SERVICE BULLETIN NO. 144A
SUPERSEDES SB NO. 144
"FAA DCA EA-4 APPROVED"

DATE: March 12, 1975
SUBJECT: MIXTURE CONTROL
SERIALS AFFECTED: All Model AA-1, AA-1A and AA-1B.
TIME OF COMPLIANCE: Within the next 50 hours of operation; thereafter,
as indicated in text.

Figure 1. Mixture Control Inspection & Installation

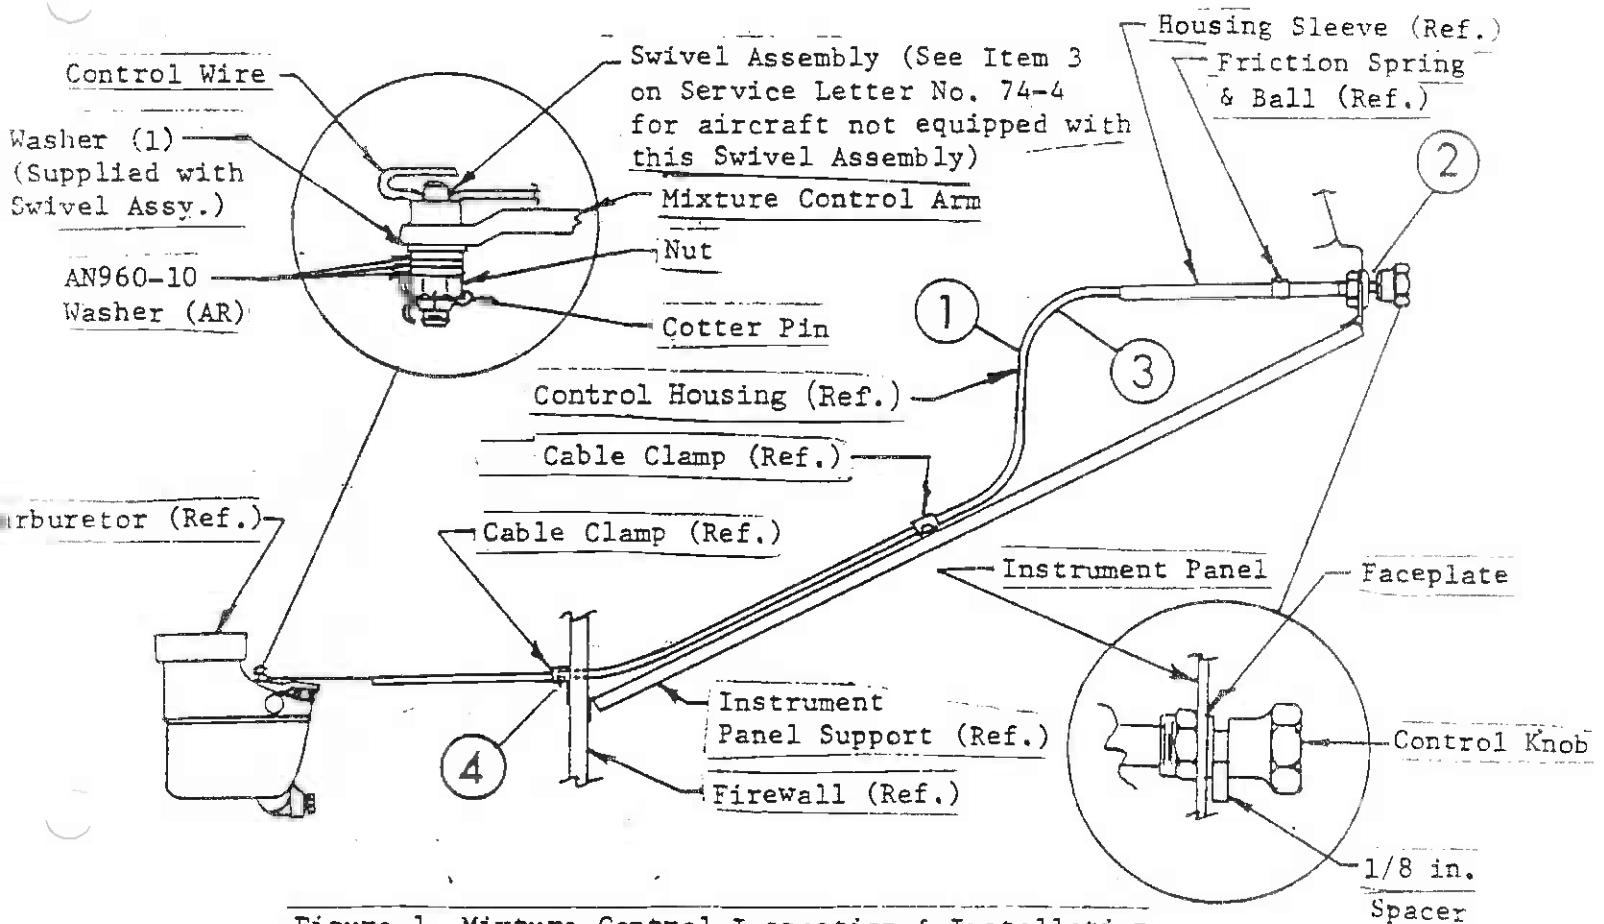
Refer to circled numbers in Figure 1 and accomplish the inspection items listed below:

1. Cycle the control knob between the full rich and idle cutoff position, and observe the control housing for a "snaking" movement. Movement of the housing indicates that the control wire is kinked and must be replaced.
2. Place the control knob in the idle cutoff position, grasp the mixture control arm and move arm to the full rich position. Measure the additional travel (sponge) remaining between the faceplate and control knob. Replace mixture control wire, if the additional travel remaining exceeds 1/8 inch.

WHEN OBTAINING THE ABOVE MEASUREMENTS, THE CARBURETOR MIXTURE CONTROL ARM MUST BE IN THE FULL RICH POSITION. IF THE ARM IS NOT IN THE FULL RICH POSITION WITH CONTROL KNOB AGAINST THE FACEPLATE, LOOSEN CABLE CLAMPS AND RERIG FOR 1/8 INCH MAXIMUM SPONGE.

3. The control housing minimum bend radius is $4\frac{1}{2}$ inches throughout its entire routing. If necessary, adjust housing and replace mixture control wire, if the minimum bend radius is less than $4\frac{1}{2}$ inches.
4. The firewall cable clamp must direct the control housing at right angles to the firewall. If necessary, adjust to achieve this condition.
5. Perform a final check of the mixture control for proper travel, security, operating condition and control cushion (sponge).

If service life limit or inspection of the control wire dictates replacement, a Control Wire/Knob Assembly is available under part number 507001-3 at \$4.50 (E) each. Refer to Figure 1 for proper installation.

1. Remove friction spring and ball from housing sleeve, detach control wire from mixture control arm at swivel assembly and remove control wire from aircraft.
2. Route replacement control wire/knob assembly through existing control housing and loosely attach to the swivel assembly.
3. Position the mixture control arm completely against the full rich stop and place a 1/8 inch spacer between control knob and faceplate.
4. With the mixture control arm against the full rich stop and the control knob against the spacer, tighten swivel assembly. Remove spacer from control knob and check mixture control for proper travel, security, operating condition and control cushion (sponge).
5. Bend mixture control wire as shown and install cotter pin. Check swivel freedom in arm.
6. Attach friction spring and ball to housing sleeve.
